GW - 45

**GENERAL  
CORRESPONDENCE**

**From:** Chavez, Carl J, EMNRD  
**Sent:** Thursday, January 11, 2007 10:46 AM  
**To:** 'Bays, David'  
**Cc:** Price, Wayne, EMNRD  
**Subject:** RE: OCD Discharge Plan Application for Williams Kutz Canyon Gas Plant (GW-045) & Keblah Compressor Station (GW-329)

**Re: Inspection Report**  
**Williams Field Services**  
**GW-045, Kutz Canyon Gas Plant**  
**San Juan County, New Mexico**

SCALE: 1" = 80'-0"  
 DWG NO. KTZ-1-P7  
 SHEET 9 OF 02

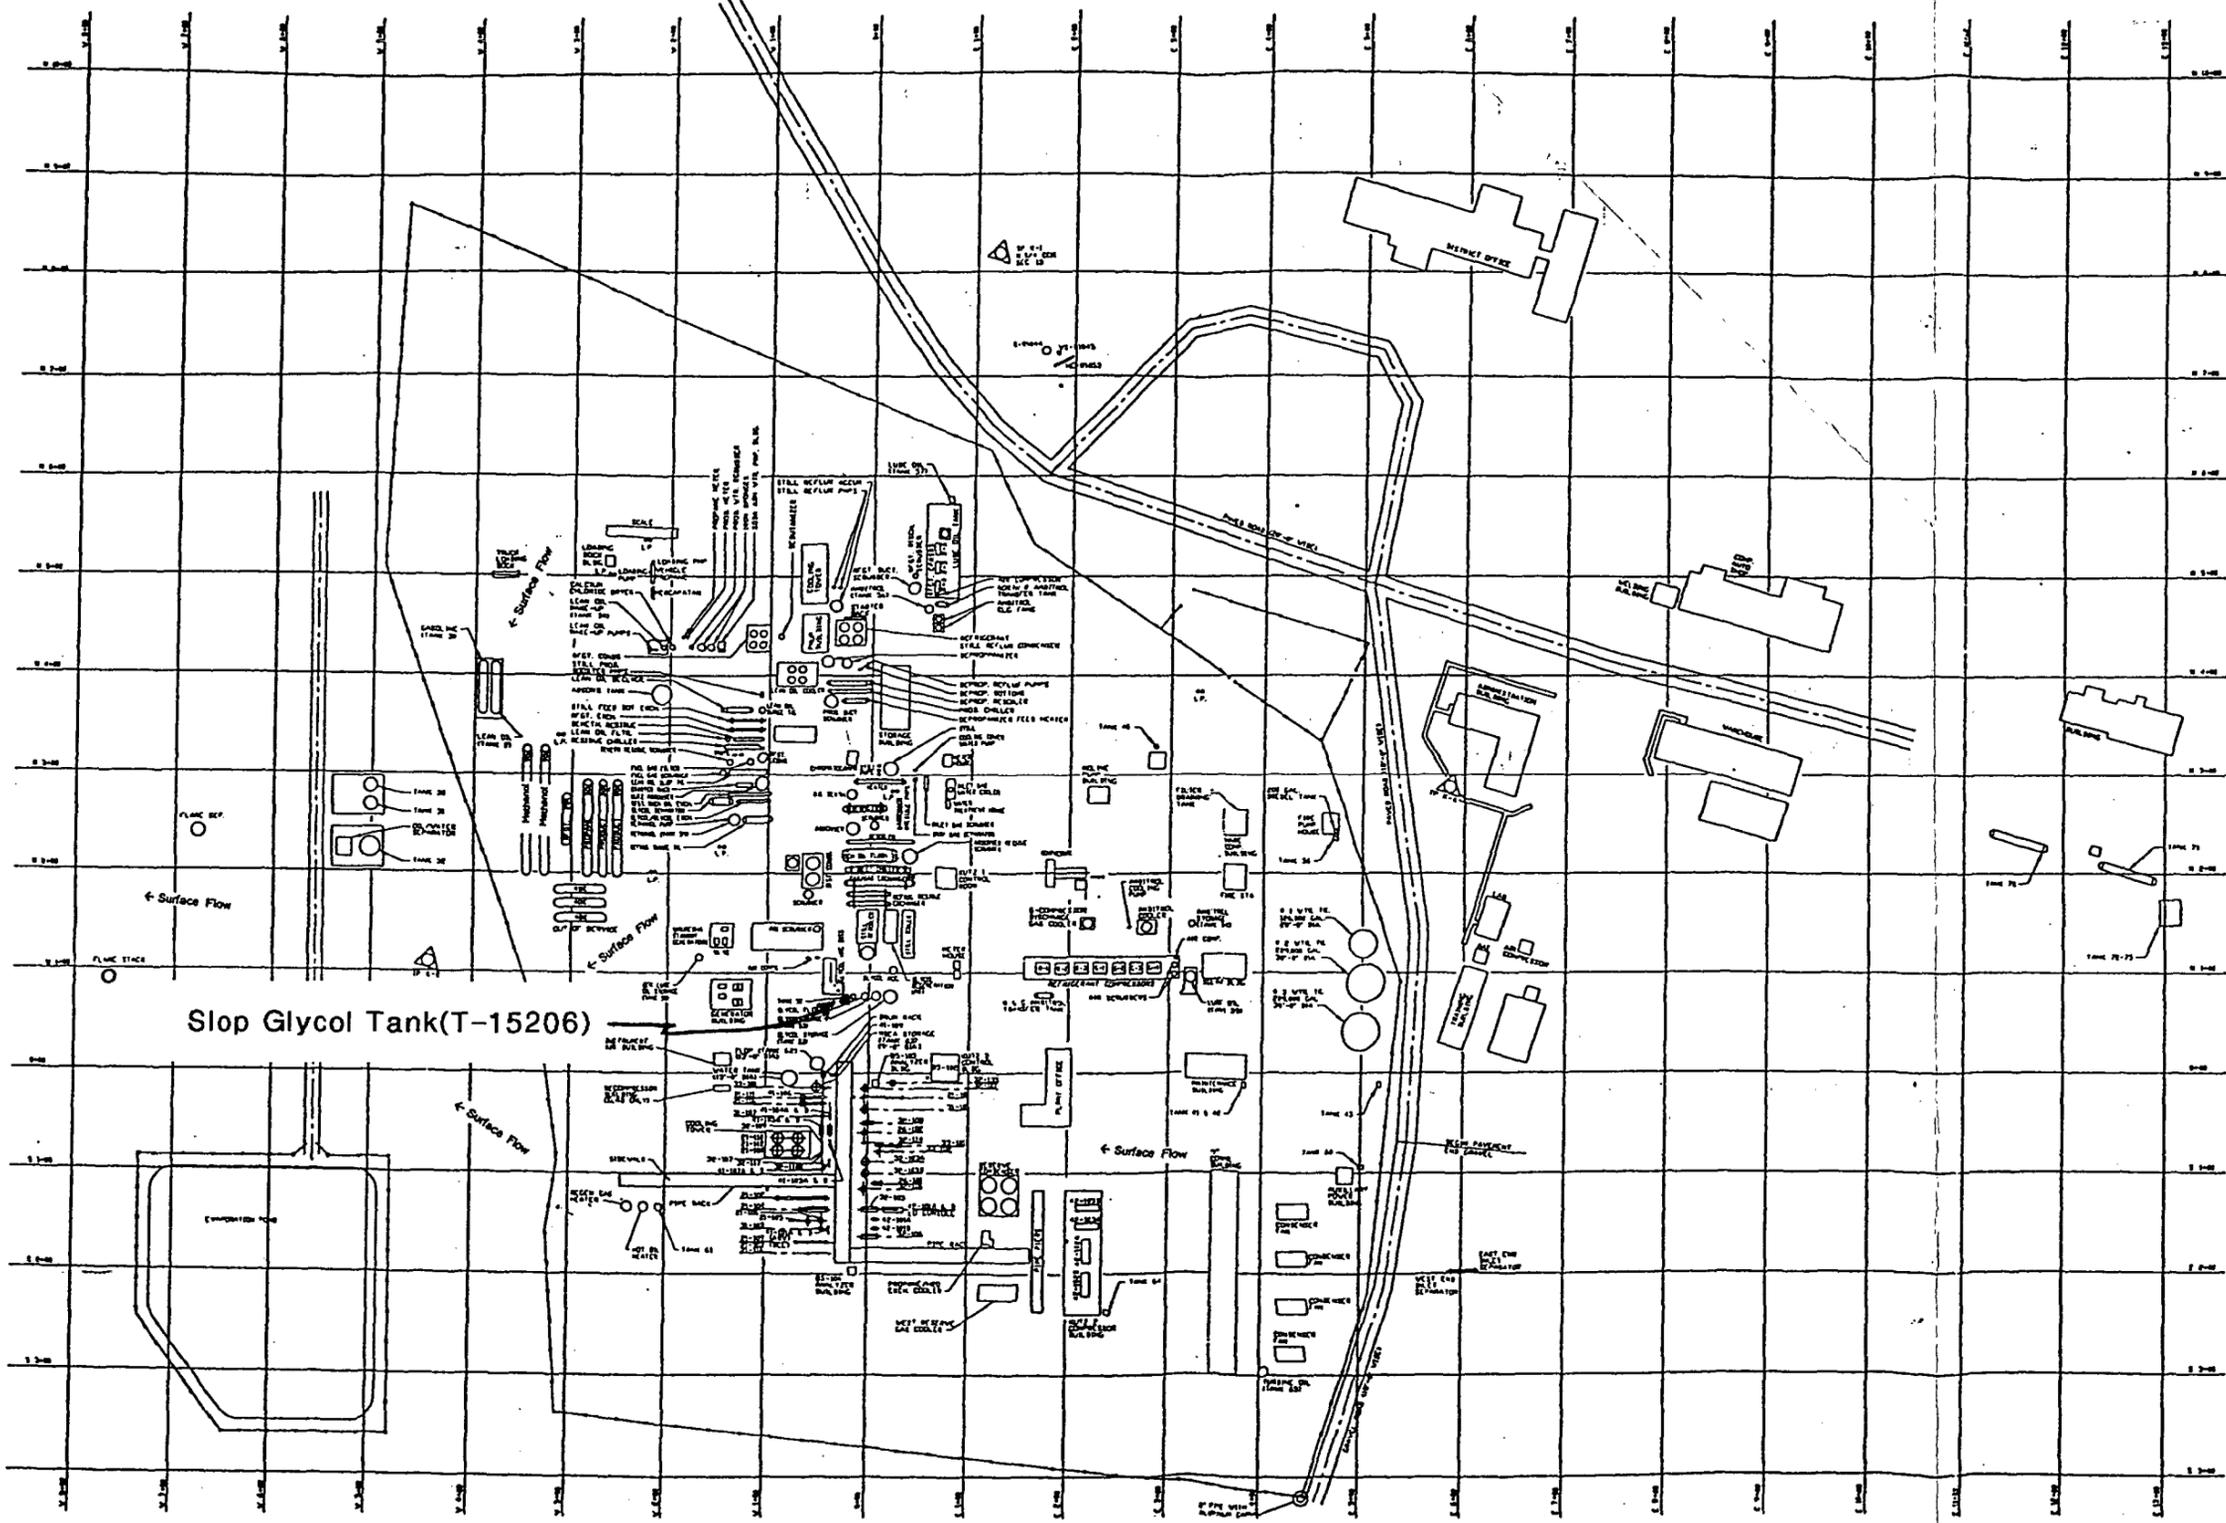
This correspondence is to request permission to locate an additional slop glycol storage tank at the reference facility. The tank will have a 1,000 gallon capacity, located within a block and concrete secondary containment, and will be identified as (T-15206). Refer to the attached Figure (KTZ-1-P7) from the Discharge Plan (February 2003).

Photo #2

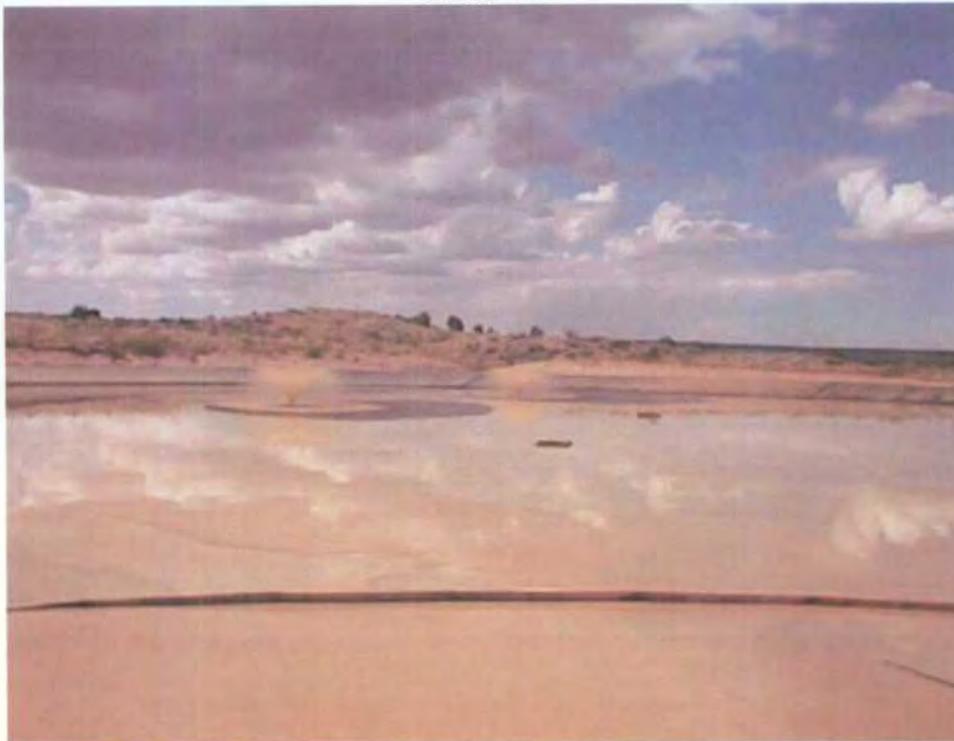
Piping and connection joints show evidence of leaks that have spilled onto the ground surface at Kutz #1 and at the oil/water separator. Some type of collection device should be provided to prevent the spillage onto the ground surface. Evidence of spillage was in the process of cleanup at the time of inspection. (Photos #1 & #2)

GW-045 WILLIAMS FIELD SERVICES KUTZ CANYON GAS PLANT  
Leak/spill onto ground surface at oil/water separator  
July 7, 1999
